# Determination 2024/001

**Regarding the issue of a dangerous and affected building notice for a residential dwelling**

**307 Lakes Boulevard, Pyes Pa, Tauranga**

**Figure 4: Wing wall design intent – Section 1-1 (not to scale)**

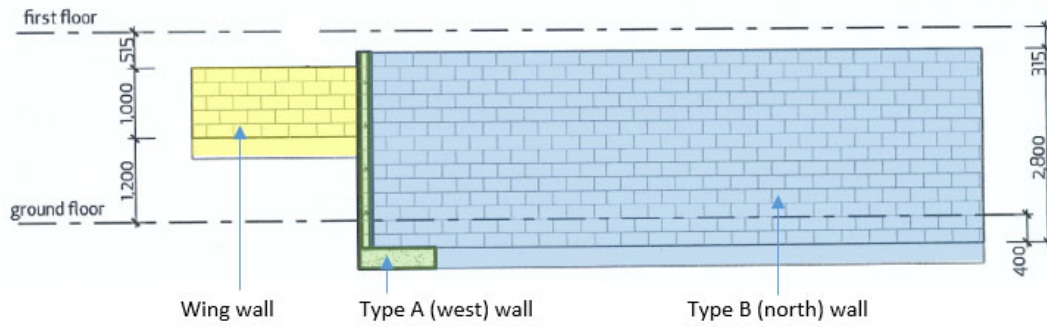
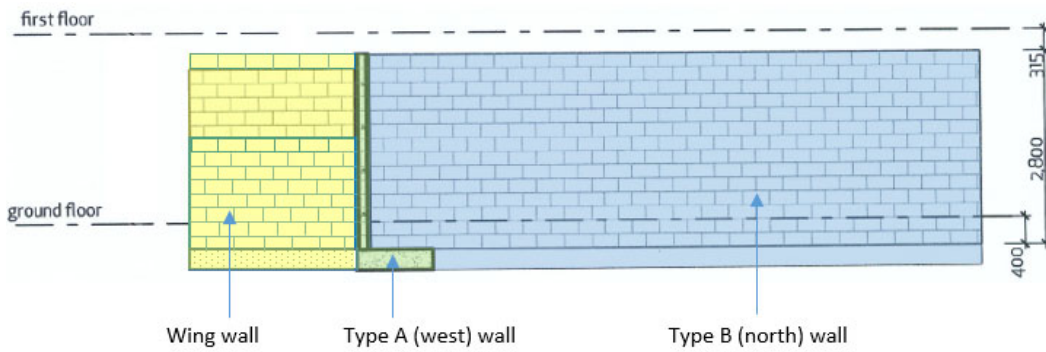
- 2.17. The building consent plans indicate that the wing wall was intended to retain approximately 800 mm depth of soil.<sup>32</sup> I note this depth of soil is greater than 600mm provided for in NZS 3604:2011.<sup>33</sup>

- 2.18. The plans also indicate the area (or “alcove”) between the wing wall and the north face of the Type A retaining wall was to be backfilled with material to approximately half the height of the Type A wall.<sup>34</sup> However, as built the Type A wall did not retain any fill material or natural soils in the alcove (see figure 6).

- 2.19. As built, the wing wall was approximately 2800mm high and supported soil and backfill material along the north face of the wall approximately 1000mm to 1800mm deep. The north face of the wing wall was protected by a self-adhesive sheet applied waterproofing membrane<sup>35</sup>, a layer of high-density polyethylene “dimpled” sheet material, and an additional layer of expanded polystyrene.

6.7.1. The wing wall was built 14 blocks in height which equates to 2.8m. This is much higher than shown on the consented plans.

**Figure 10: West elevation of 307A Lakes Boulevard (not to scale)<sup>117</sup>**

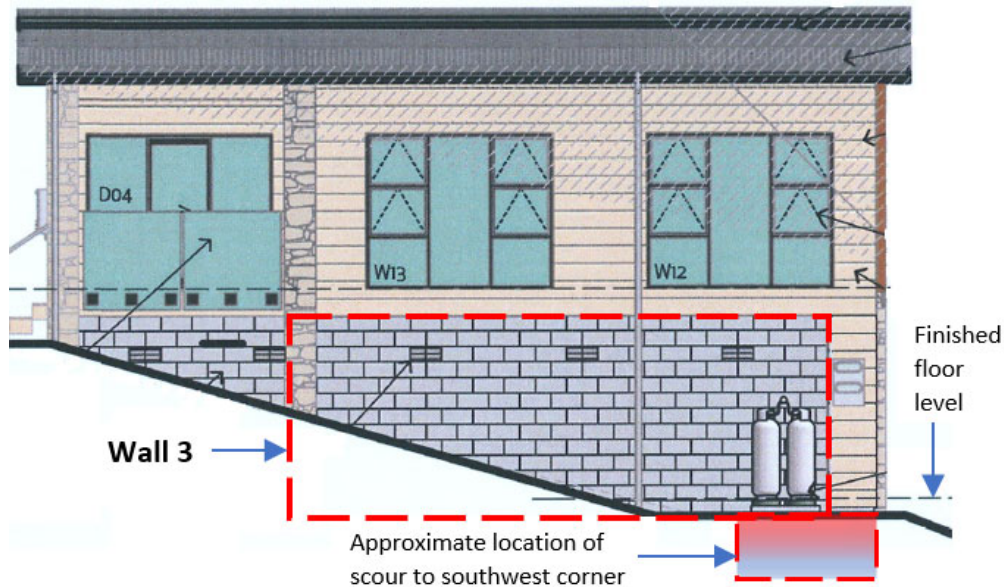
<sup>117</sup> Figure 10 has been reproduced in part from plan 302 revision B. The area highlighted only shows the approximate location of the scour and is not intended to represent the size or extent of the scour.

Figure 11: Wall 3 and foundation (not to scale)<sup>120</sup>

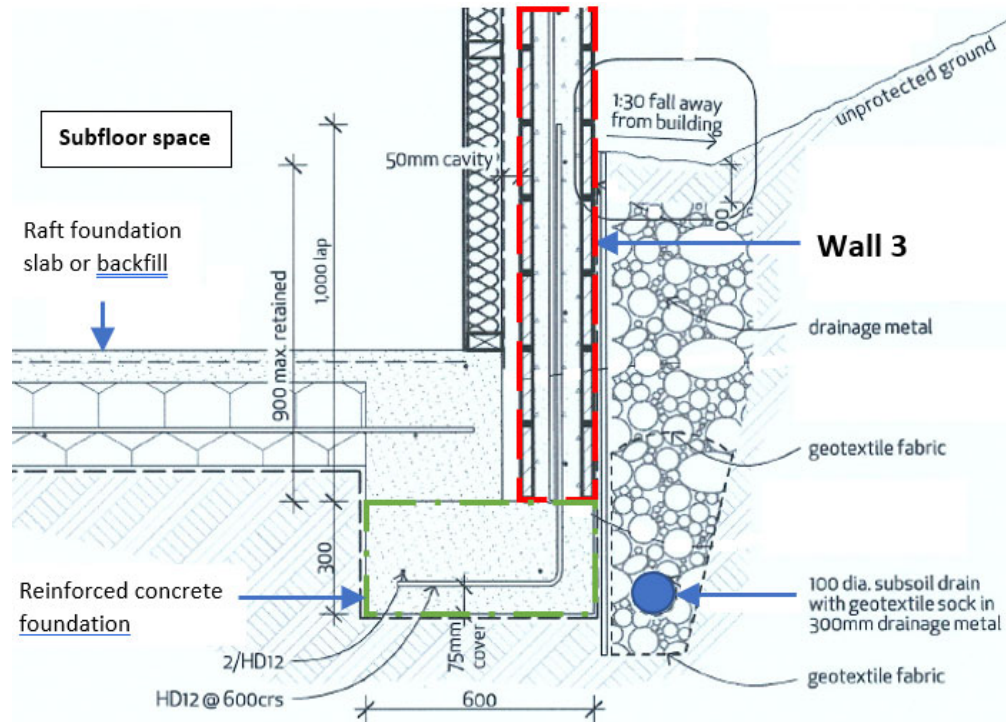
- 7.8.3. Taking into account the design information regarding the depth of the foundations<sup>119</sup>, it was concluded the footing for Wall 3 would have been constructed 700mm below finished floor level and this would have been at or close to the invert of the perforated drain coil (refer to figure 11).

**Figure 12: Area between 307A Lakes Boulevard (on the right) and 305 Lakes Boulevard (on the left)<sup>124</sup>**

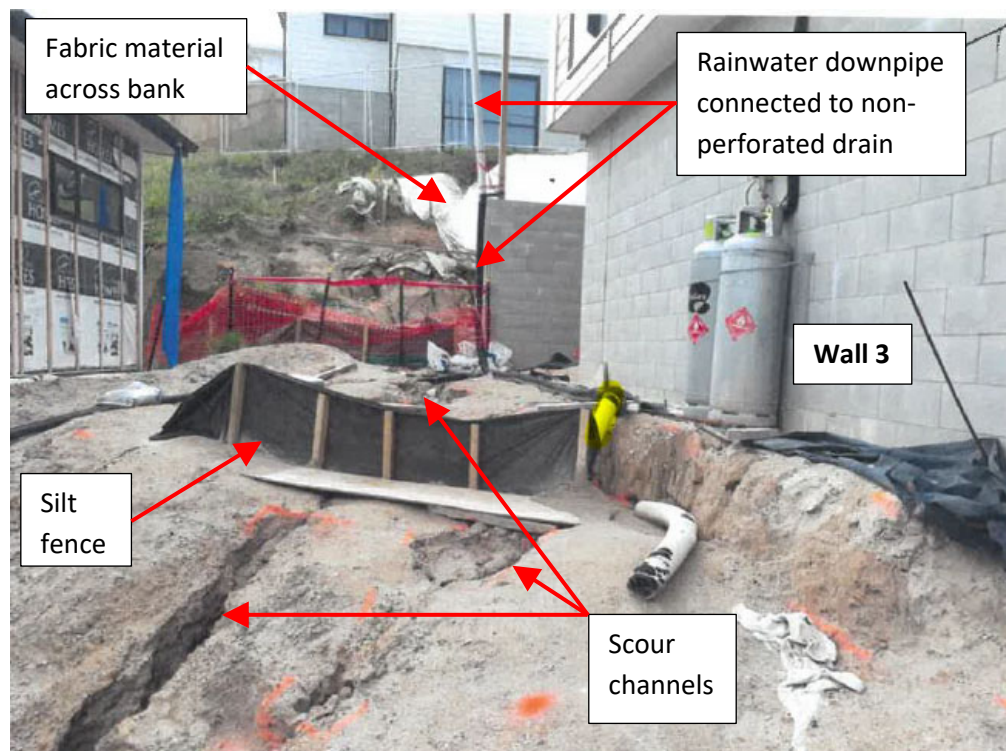
7.8.10. The recorded behaviour on the site indicated that both runoff from a large, exposed area of the ground surface and discharges from downpipes carrying roof water generated scour channels.<sup>123</sup> The channels were typically narrow but could extend to greater than 1m below the ground surface. For scour to form there must be a source of water that saturates the soil, and the velocity of water flow is a critical factor (eg as a result of a steep gradient). Saturation reduces the soil's shear strength, making it susceptible to erosion. Refer to figure 12.

7.8.12. The direction of scour (as indicated in figure 12) is oriented away from 307A Lakes Boulevard and is some distance horizontally away from Wall 3, mitigating concerns regarding the structural performance of the dwelling.

**Figure 13: Southwest corner of 307A Lakes Boulevard<sup>126</sup>**

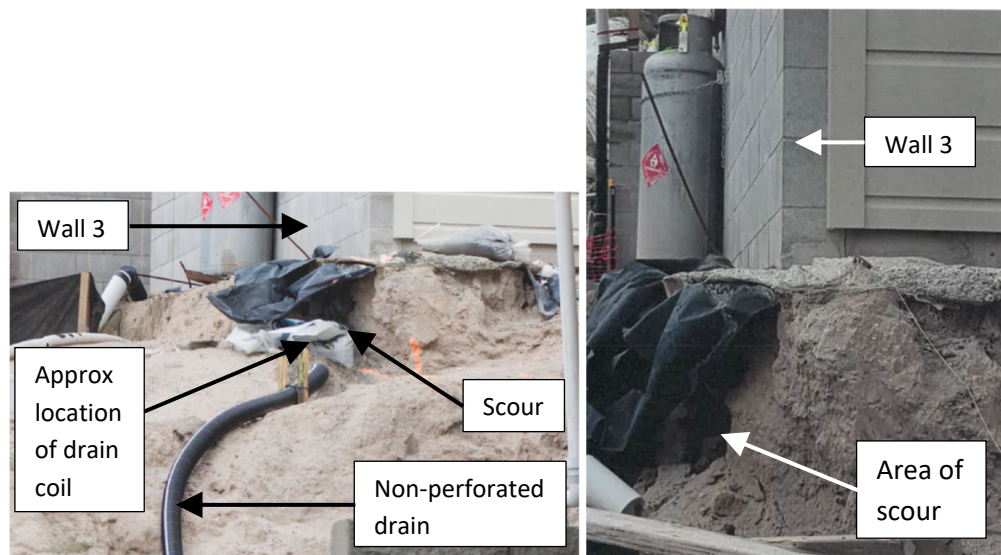
- 7.8.16. The scour feature (shown in figure 13) likely formed in this location due to the need for an exit point for the drain coil system prior to the connection of the additional non-perforated drain and adjacent to, not beneath, Wall 3.
